**Revision to a Request for Supply
Arrangement - Révision à une demande
pour un arrangement en matière
d'approvisionnement**

Title - Sujet Furniture for Work Spaces	
Solicitation No. - N° de l'invitation E60PQ-140003/C	Date 2018-05-18
Client Reference No. - N° de référence du client E60PQ-140003	Amendment No. - N° modif. 005
File No. - N° de dossier pq992.E60PQ-140003	CCC No./N° CCC - FMS No./N° VME
GETS Reference No. - N° de référence de SEAG PW-\$\$PQ-992-74154	
Date of Original Request for Supply Arrangement 2018-01-17 Date de demande pour un arrangement en matière d'app. originale	
Solicitation Closes - L'invitation prend fin at - à 02:00 PM on - le 2019-04-30	
Time Zone Fuseau horaire Eastern Daylight Saving Time EDT	
Address Enquiries to: - Adresser toutes questions à: Vlahos, Helen	Buyer Id - Id de l'acheteur pq992
Telephone No. - N° de téléphone (613) 220-8951 ()	FAX No. - N° de FAX () -
Delivery Required - Livraison exigée	
Destination - of Goods, Services, and Construction: Destination - des biens, services et construction:

This amendment 005 to E60PQ-140003/C is raised for the following purpose:

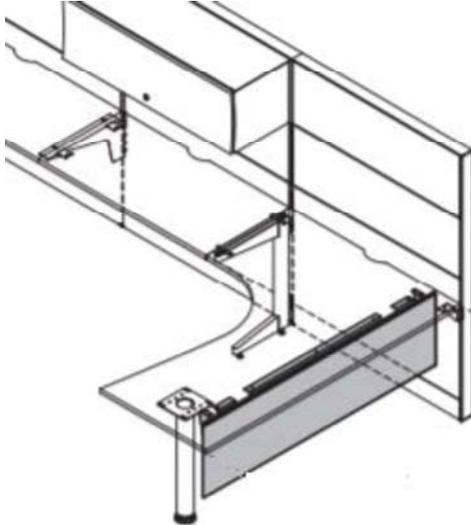
Q111 b) - Please confirm if the work surface is fully panel mounted despite it being included in the "Freestanding" section? If it is fully panel mounted, then the modesty panel would be installed in front of the panel it is mounted to, so there would be no reason to include the modesty panel. Please delete the modesty panels from the panel mounted work surfaces on the catalogue. We may be misunderstanding your request, so please provide a drawing.

Delete: 3.2.1.1.3 Fixed height *work surfaces* must be available with modesty panel. The modesty panel must:

- .1 The modesty panel must not prevent access to wall outlets, or interfere with *work surface* supports and power/data access.
- .2 The modesty panel must be installed parallel with the width of the *work surface*.

Insert: 3.2.1.1.3. : Fixed height work surfaces must be available with modesty panel **unless panel mounted or the work surfaces runs parallel to a wall.**

- .1 The modesty panel must not prevent access to wall outlets, or interfere with *work surface* supports and power/data access.
- .2 The modesty panel must be installed parallel with the width of the *work surface*.

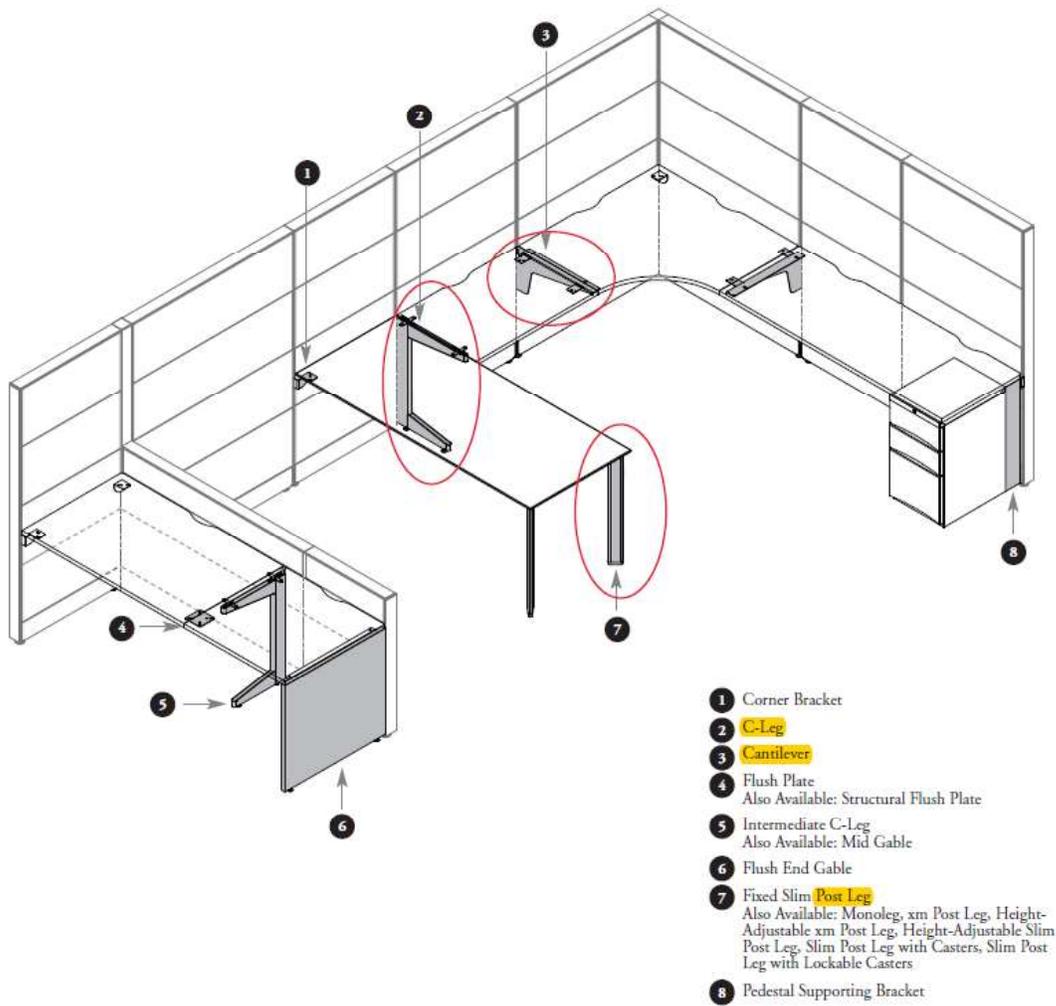
For the compartment without a door, is a side-access storage acceptable as shown on this image?

Yes- This would be acceptable

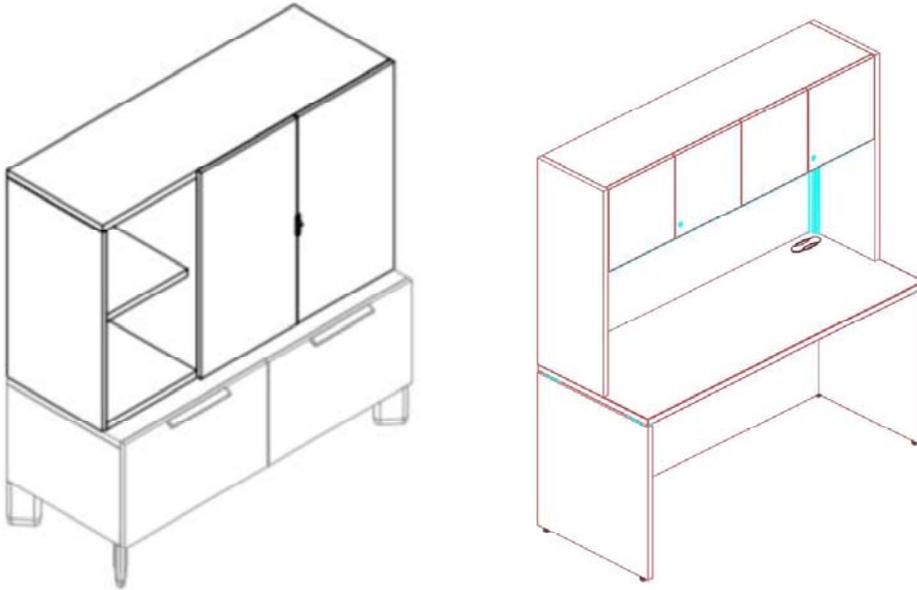
Q139- 3.2.5.5.1 – Hutches must be... affixed to a desk or a low credenza unit. The description in the specification and in the Category 1b Catalogue does not distinguish between a Hutch on a low credenza (stack-on) or a Hutch with gables that would have a space to install a light (installed on a desk). See images below. Please revise the Category 1 catalogue to delete “fixed” and “desk mounted” and replace with (a) Desk mounted with Gables; (b) Credenza mount with gables (c) Credenza mounted without gables (on lines 621-940 & 1261-2220). Definitions 1.6.18 pg 44 does not clearly distinguish between fixed vs desk mount.

Response: A Hutch must be: (a) Desk mounted with Gables; (b) Credenza mounted with gables or (c) Credenza mounted without gables to be added to catalogue, replacing “Fixed” and “Desk Mounted”.

Delete 1.6.18 A hutch: Is secured to the top of a credenza unit and provides storage and seated privacy to the end user.

Insert 1.6.18 A hutch: Is secured to the top of a credenza unit, a desk or provides storage and seated privacy to the end user.

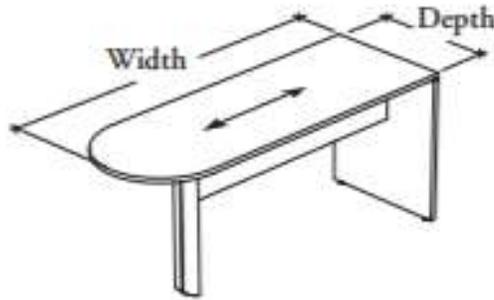
Q141- generally has a gable on one side and some other support on the other (see picture). Category 1b Lines 349-438, includes Panel Mounted, C-Legs, Post-Legs, 1 Half Height Gable plus 1 full Gable and 2 Full Gables. This excludes the most common option (see picture below). Please add an option for 1 full gable and Post Leg.

Response: When various styles of leg supports are required, the floor plans and the **Additional Products and Details** section in RFB of the solicitation should capture the requirement for the purchaser.
